**Transvaal Terrace/Carlinghow Hill, Batley
Proposed Residential Development
Stage 1 Road Safety Audit**

January 2020 (Initial Issue)

Prepared on behalf of
Fernbrook Associates Ltd

Appendix A Problem Location Plan

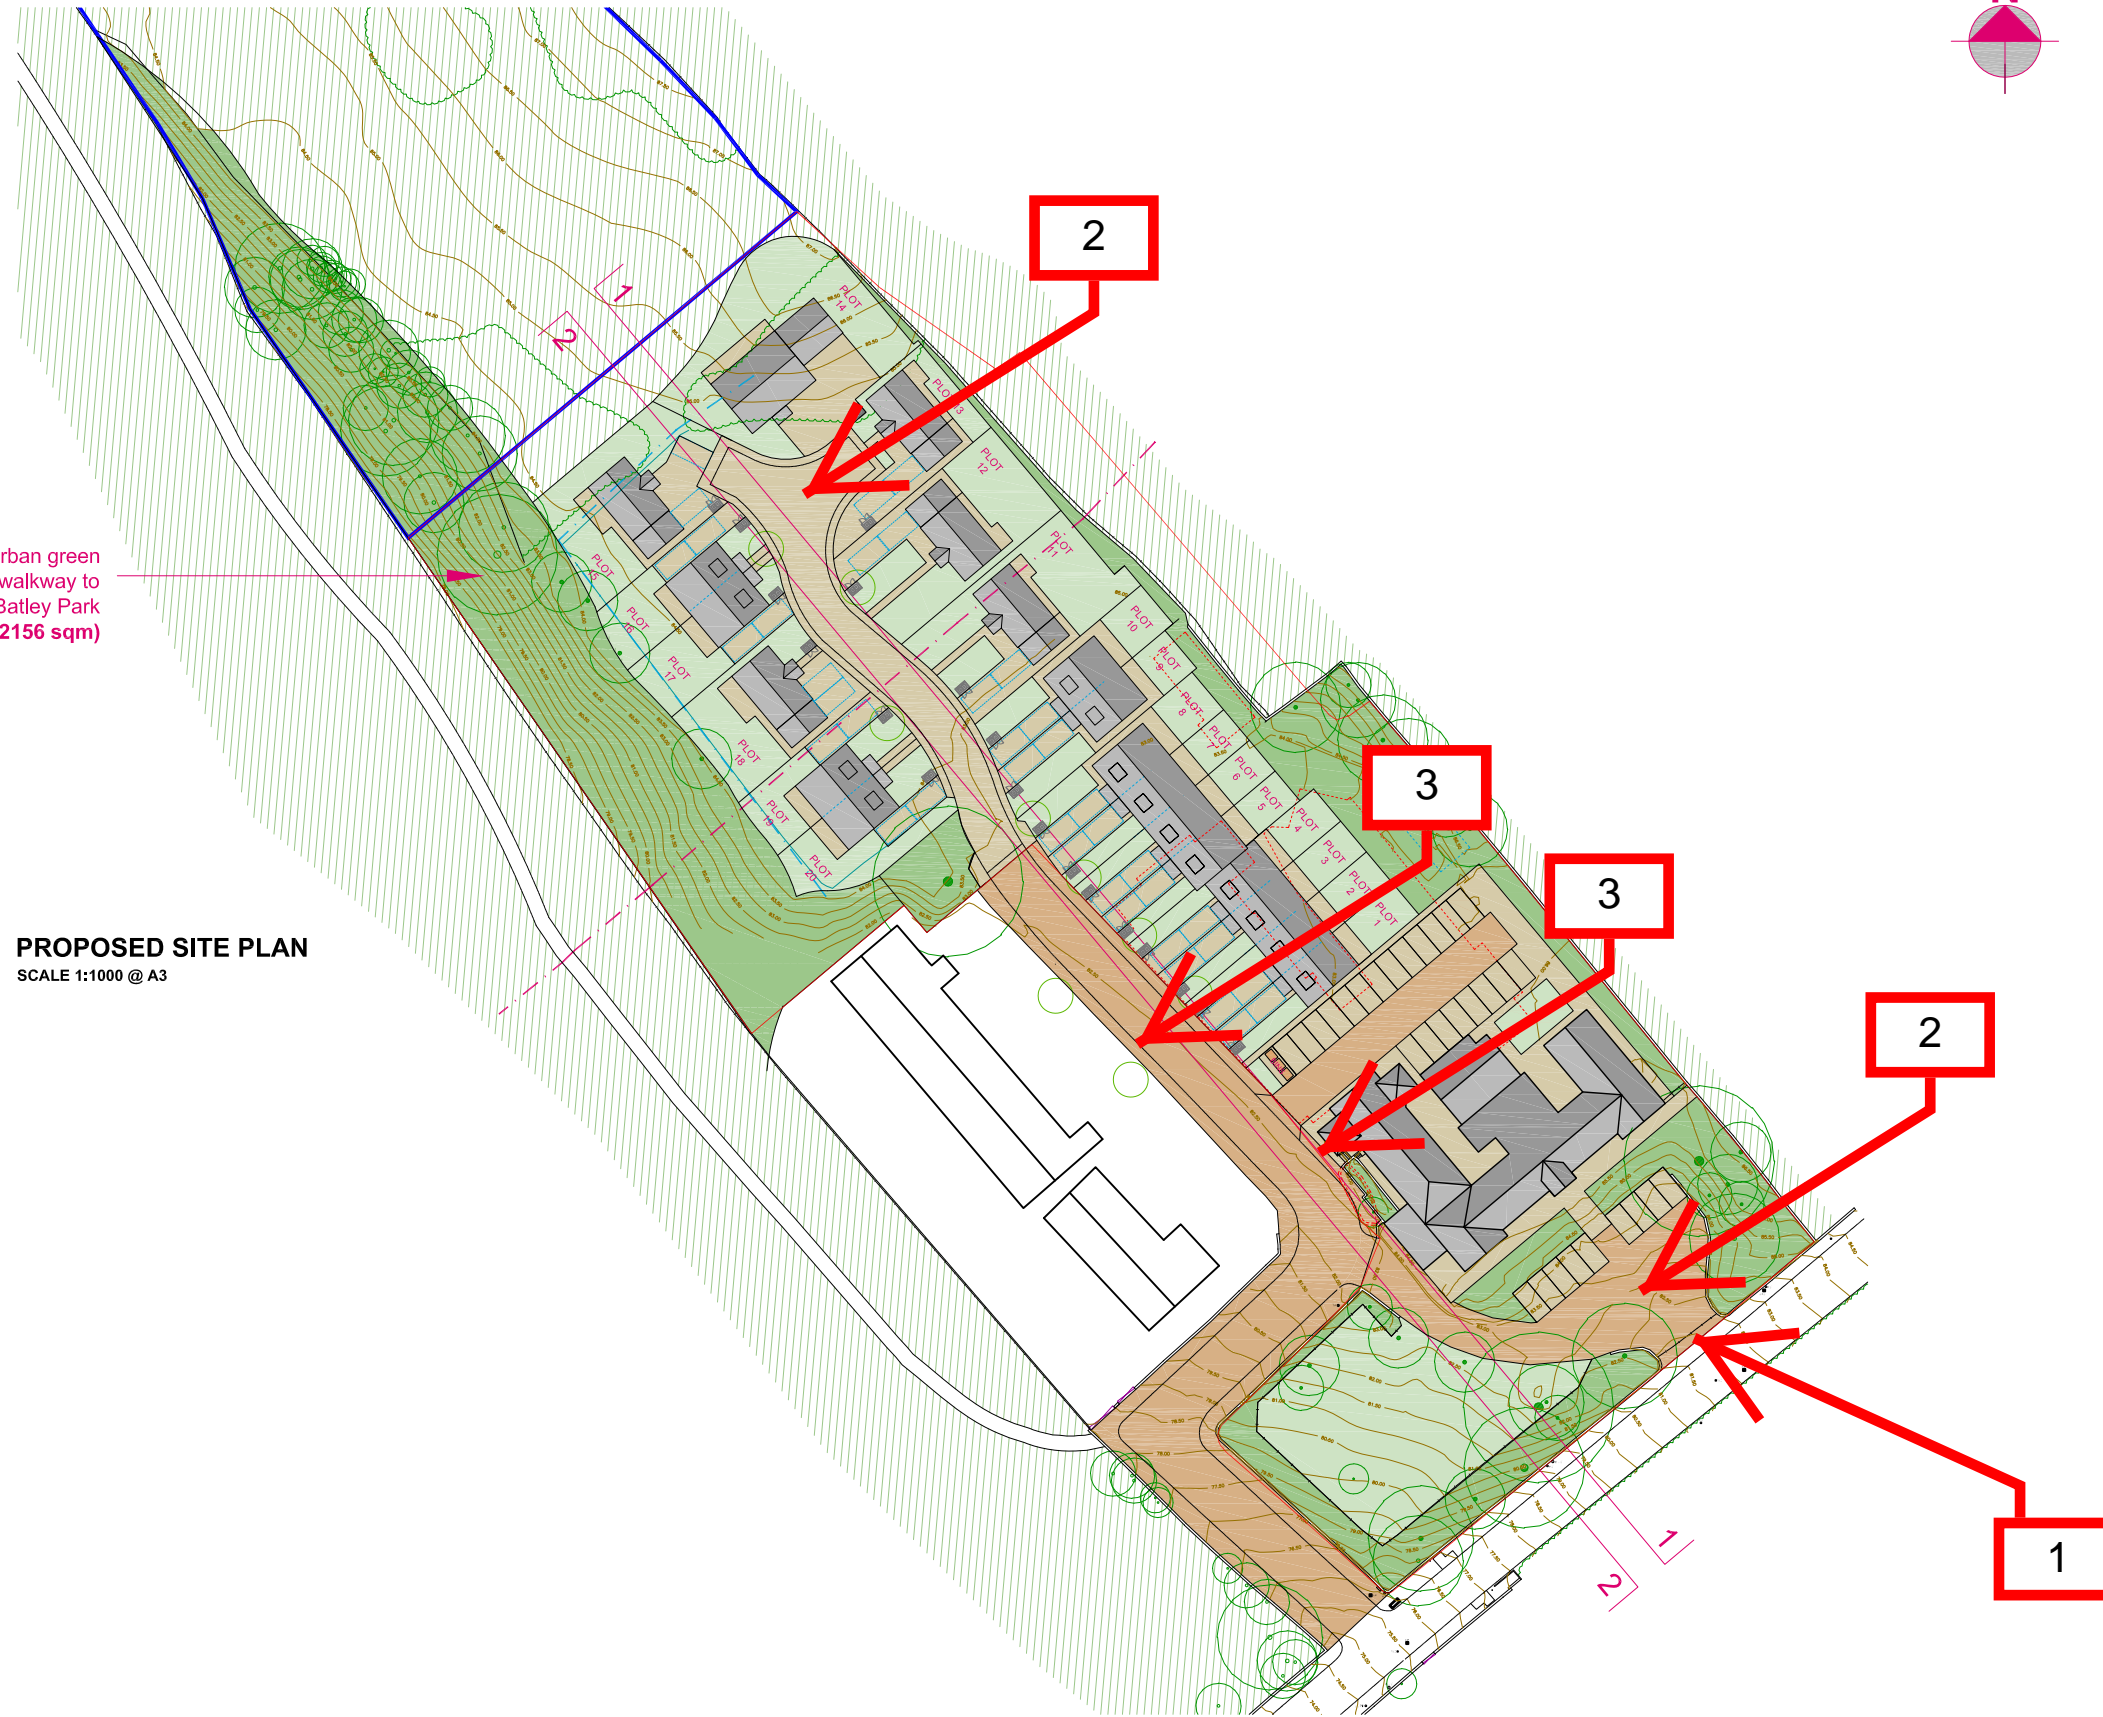
PROBLEM	
Location	Apartment access.
Summary	Existing boundary walls and vegetation restrict visibility and increases the potential for a collision between a vehicle emerging from the development and traffic travelling along Carlinghow Hill.
<p>Junction visibility splays at the secondary access serving the apartments are not indicated on the drawings provided and no vehicle speed data has been supplied to the Road Safety Audit Team. However, the existing boundary walls and vegetation to either side of the junction restrict visibility in both directions as shown within the images below.</p> <p>Insufficient junction visibility could lead to a collision between a vehicle emerging from the development and those travelling along Carlinghow Hill.</p>

PROBLEM	
Location	Proposed turning facilities.
Summary	The proposed turning facilities could result in the potential for a collision between a turning service vehicle and other road users.
<p>The Transport Statement includes an extract of a swept path analysis using a 10m rigid vehicle turning within the apartment car park and the turning facility at the head of the cul-de-sac.</p> <p>Firstly, it is noted that the swept path analysis has been undertaken on an alternative layout fronting the apartments, which does not include 9 proposed car parking spaces, thereby reducing the available space.</p> <p>The swept path analysis has also been undertaken using a 10m rigid vehicle rather than a standard Kirklees refuse vehicle which is 11.85m in length.</p> <p>Based on the tracking exercise undertaken (which is not to a scale) it appears unlikely that this size of vehicle can enter and exit the development in a forward gear, leading to potential overrunning of driveways/margins/parking spaces or excessive reverse distances in conflict with other road users.</p>

PROBLEM	
Location	Internal access road.
Summary	The footway provision may lead to pedestrians stepping out into the carriageway.
<p>The initial circa 120m length of Transvaal Terrace is laid out as a traditional estate road with footways to both flanks. Beyond this a shared surface is provided serving the rear portion of the development.</p> <p>The existing footways over the initial length of Transvaal Terrace are approximately 2.0m wide between Carlinghow Hill and the apartment access, however beyond this point the footways vary in width between circa 1.2m and 2.0m fronting the new properties and rear apartment car park.</p> <p>A 2.0m wide footway is generally regarded as the minimum unobstructed widths for pedestrians. A footway width below 1.5m is insufficient to accommodate a wheelchair user/pram and a pedestrian side by side and therefore could result in pedestrians discharging into carriageway when passing, resulting in the potential conflict with oncoming road users.</p>

Recommendation	
<p>It is recommended that the current level of visibility is compared against the recommended level of visibility, applying Manual for Streets guidance, based on the results of a vehicle speed survey. Should the level of visibility prove to be substandard, it is recommended that the existing boundary wall and vegetation is removed and set to the rear of the visibility splay or access to the front of the apartments is taken via Transvaal Terrace to enable this access to be permanently closed.</p>

Recommendation	
It is recommended that a swept path analysis of the proposed turning facilities is undertaken using a large refuse vehicle (specification included within the Kirklees Highway Design Guide SPD) and the turning areas are amended accordingly.

Recommendation	
It is recommended that consistent 2.0m wide footways are provided to both flanks of the proposed access road.
